Office Action Summary

10/719,245

MASTROMATTO ET AL.

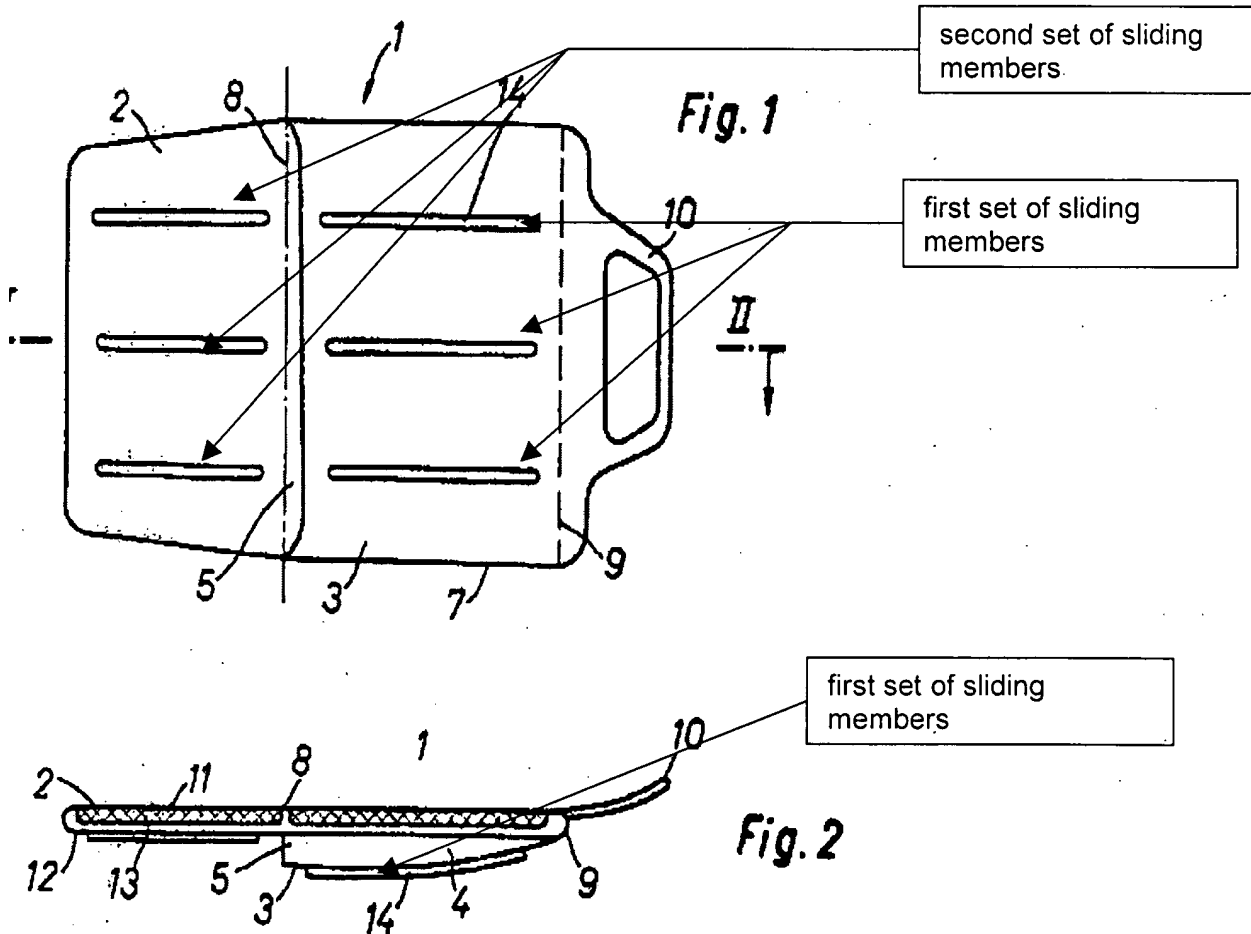
Rickenbacher (4,170,367) discloses a sliding device comprising:

a sheet of material, made from a plastic material (col. 2, lines 44-48) having a lower face; a plurality of sliding members (14,14) (Figs. 1 and 2) coupled to and protruding from (see Fig. 2) the lower face of the sheet of material being spaced each other to form

a grid of sliding members and each of the sliding member (14,14) has a substantially convex outer surface (see Fig. 2) for facilitating sliding on the support surface.

Re claims 2,3, and 20, Rickenbacher (4,170,367) (see Exhibit B) shows a first set of sliding member (14) and a second set of sliding member positioned between the front edge, a rear edge, and side ends wherein the first set is substantially larger (in length) than the second set of sliding members.

Re claims 21 and 22, Exhibit B (in figure 1), as best understood, shows that each sliding member has a perimeter having four arcuate segments and four junctures.

Exhibit C1

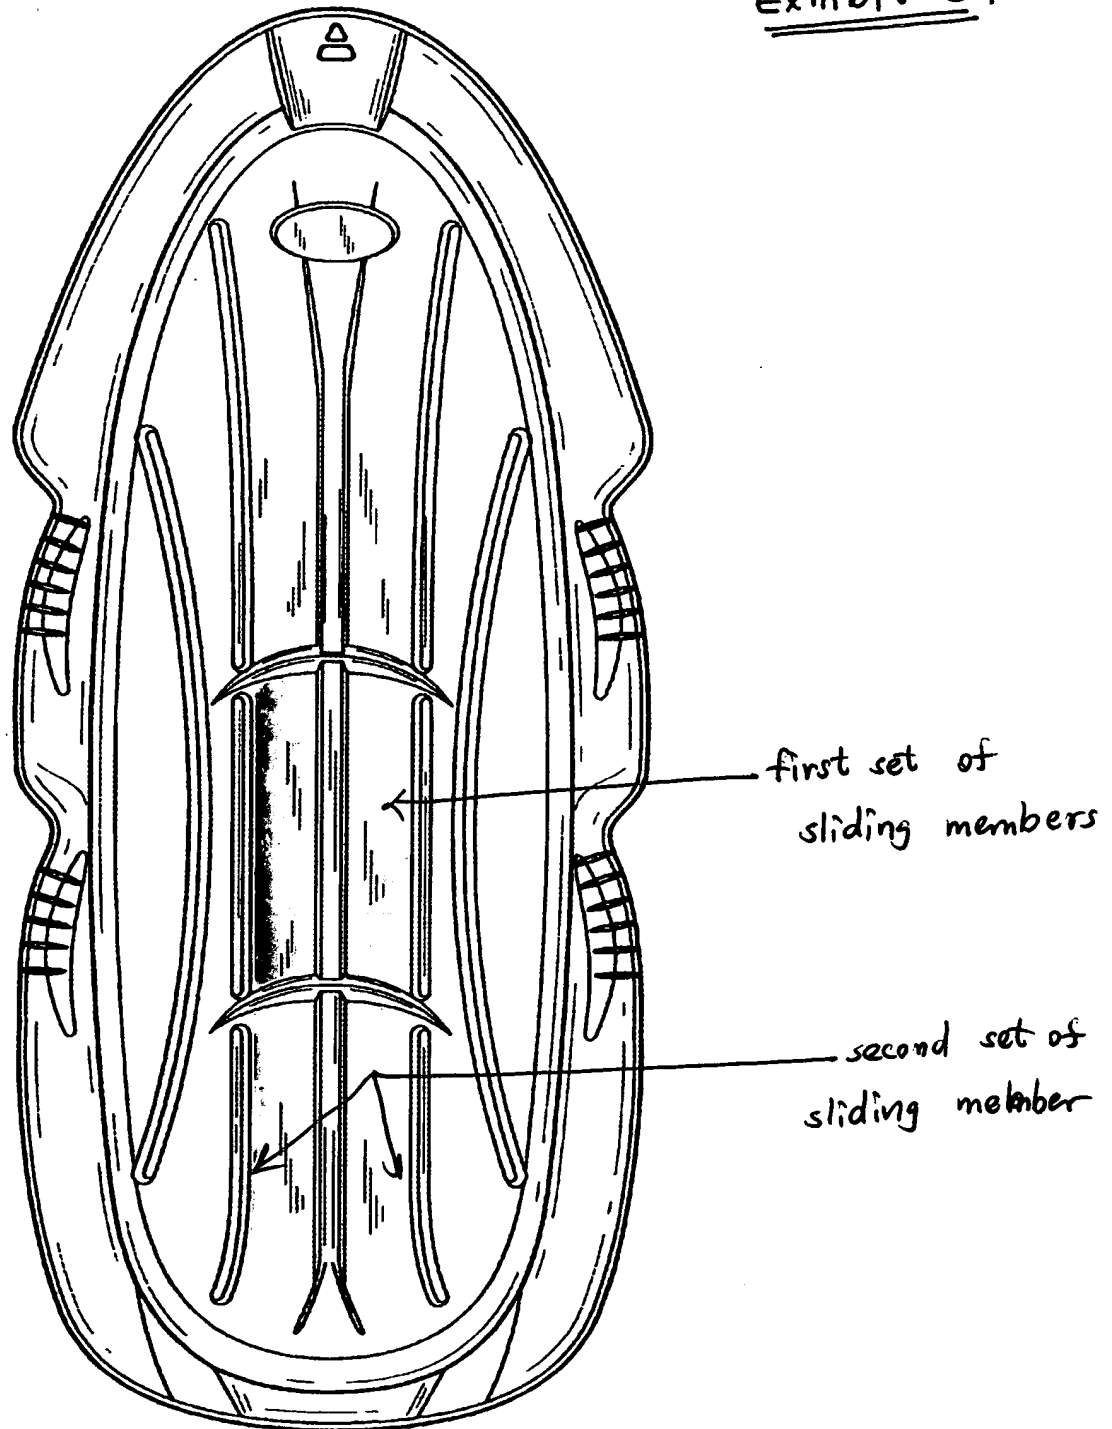
Eckert (D475,947) shows a sliding device comprising a sheet of material, having a lower face; a plurality of sliding members (see Fig. 3, bottom view) coupled to and protruding from (see Figs. 4 and 5) the lower face of the sheet of material being spaced each other to form a grid of sliding members and each of the sliding member has a substantially convex outer surface (see Figs. 4 and 5) for facilitating sliding on the support surface. Re claims 2,3, and 20, Rickenbacher (4,170,367) (see Exhibit C1 and C2, attached) shows a first set of sliding member (highlighted with orange color) and a second set of sliding member positioned (highlighted with yellow color) between the front edge, a rear edge, and side ends wherein the first set is substantially larger than the second set of sliding members.

Re claim 4, Exhibit C1 shows that the second set of sliding members surround the first set of sliding members.

Re claims 21 and 22, Exhibit C1 and C2, as best understood, show that each sliding member has a perimeter having four arcuate segments and four junctures.
